Description of Use Screened in porch

# RESIDENTIAL PLAN CORRECTION SHEET

**ADDENDUM to Permit No.** 843-77  
**Owner** G. MILLER  
**Location** 245 SPARCLIFF DR.

PROFILE OF SCHEMED-111--  
 POACH-GREY & MILLER  
 245 BRIDGECREASE DRIVE  
 SCARLETT, GA 31106

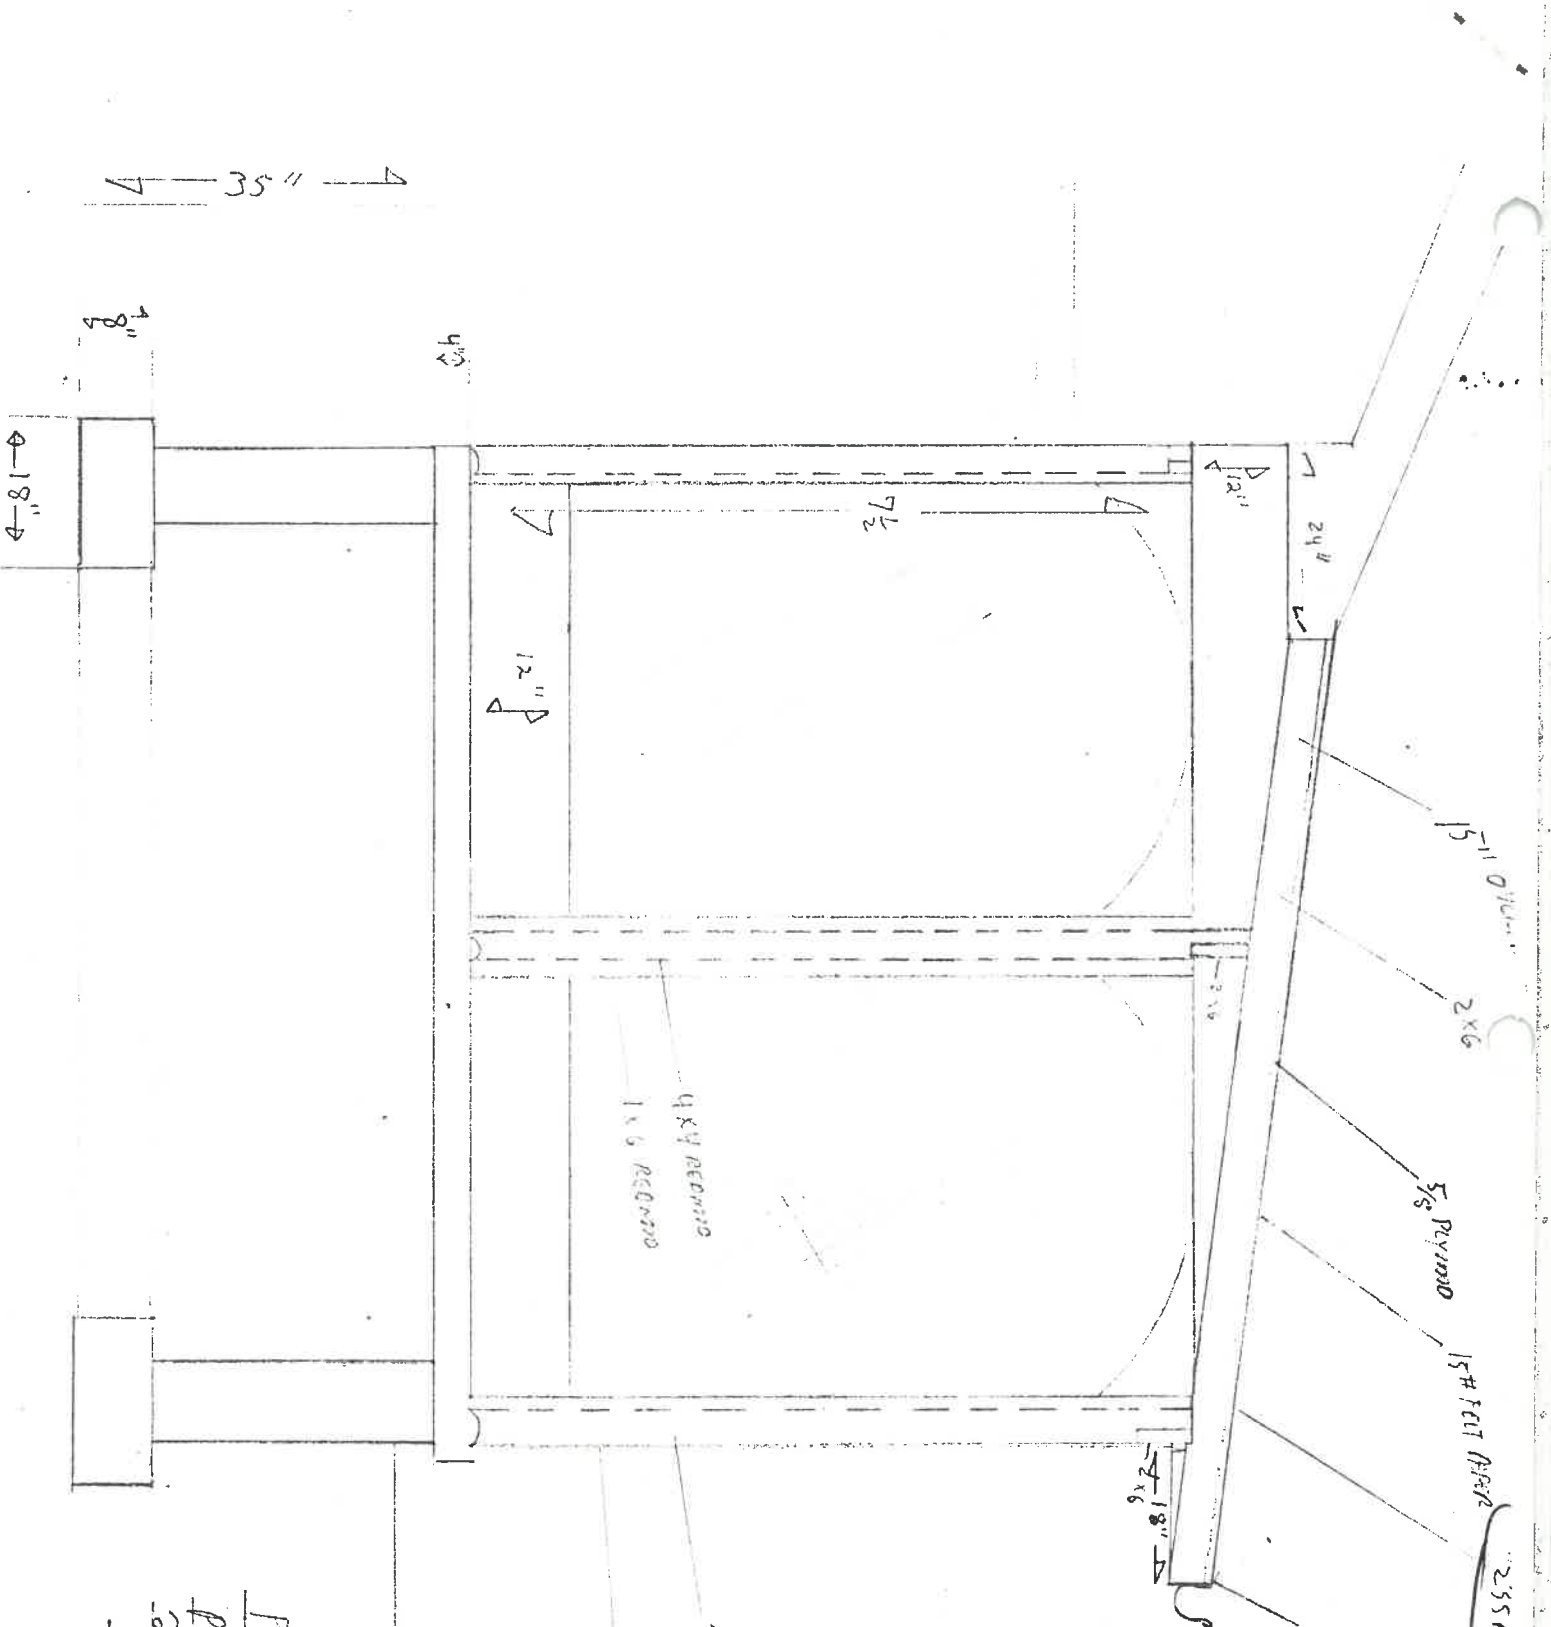
<b>GENERAL</b>	<input checked="" type="checkbox"/> Show size of members supporting porch roof.
Provide 1 approved smoke detector.	Provide double top plate.
Provide 1 hour fire wall and/or ceiling between garage and dwelling.	Provide design data for pre-fab. wood truss/members.
Provide (Class B) 1 hour fire rated door from garage to dwelling.	Ceiling joists undersized in.....
Submit fully dimensioned plot plan.	Roof rafters undersized in.....
Provide 1-3'0" x 6'8" exit door.	
Provide min. 22" x 30" attic access.	<b>PLUMBING AND MECHANICAL:</b>
Provide min. 18" x 24" crawl space access opening.	Terminate all exhaust systems to outside air.
<b>LIGHT AND VENTILATION:</b>	Insulate ducts in unheated areas.
Provide mechanical exhaust or window in bathroom.....	Provide back flow device on all hose bibs.
Provide Min. _____ sq. in. net free area attic ventilation.	<b>ELECTRICAL:</b>
Provide min. _____ sq. in. net free area crawl space ventilation.	Show location of service entrance and service equipment panel.

Show size of headers for openings over 4' wide.	Install factory built fireplaces/stoves according to manufacturers recommendations.
	Terminate chimney 3' above roof or 2' above highest point of building within 10' of chimney.
	<input checked="" type="checkbox"/> ANCHOR 4"x4" REDWOOD COLUMNS.

**ADDITIONAL CORRECTIONS:** NEW RAFTERS ATTACHED TO HOUSE SHALL BE SUPPORTED BY A LEDGER OR APPROVED JOIST HANGERS. ASPHALT SHINGLES NOT TO BE USED ON ROOFS WITH SLOPE LESS THAN 4" IN 12"

NOT FOR ROOFS WITH LESS THAN 4" IN 12" SLOPE.  
*Red.*

GREY A. MILLER  
245 BRANCLIFF

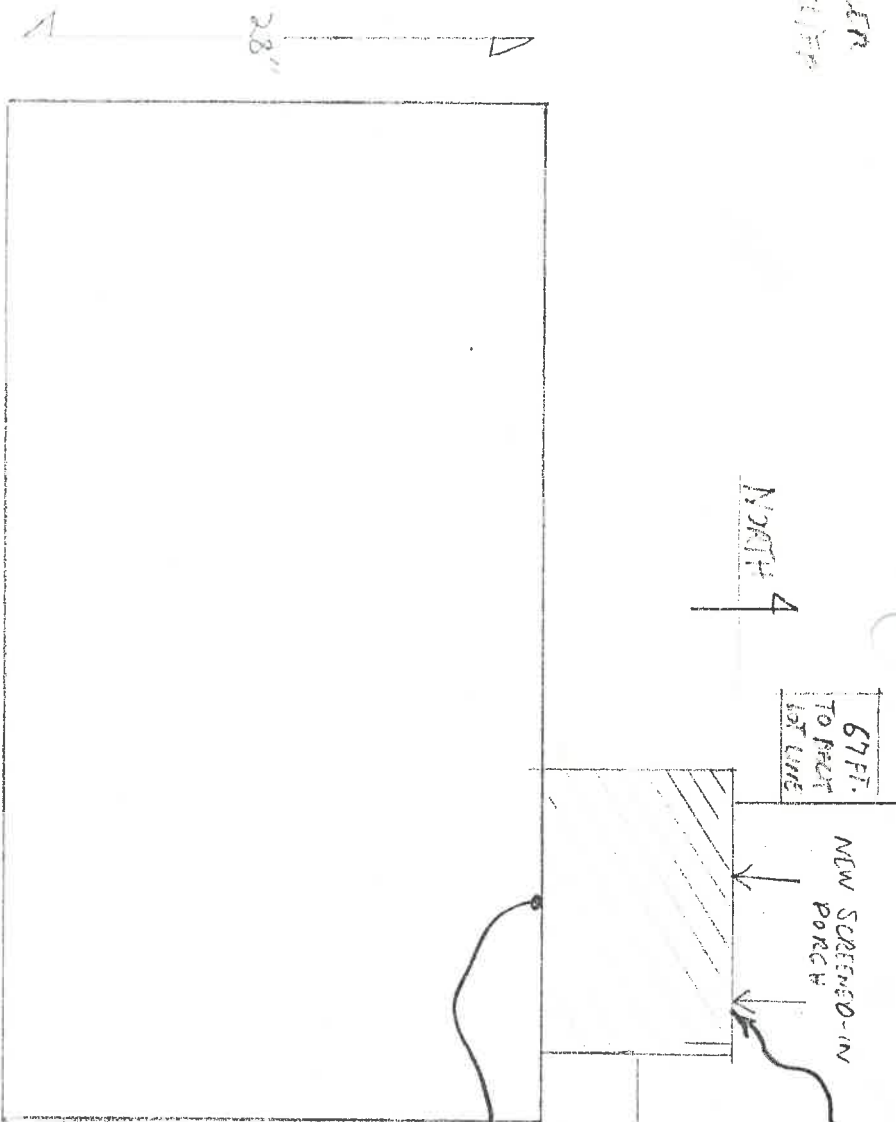
Show size of Header and spacing of supports for this wall. *AB1.*

Use ledgers or joist hangers where attaching to house *AB1.*
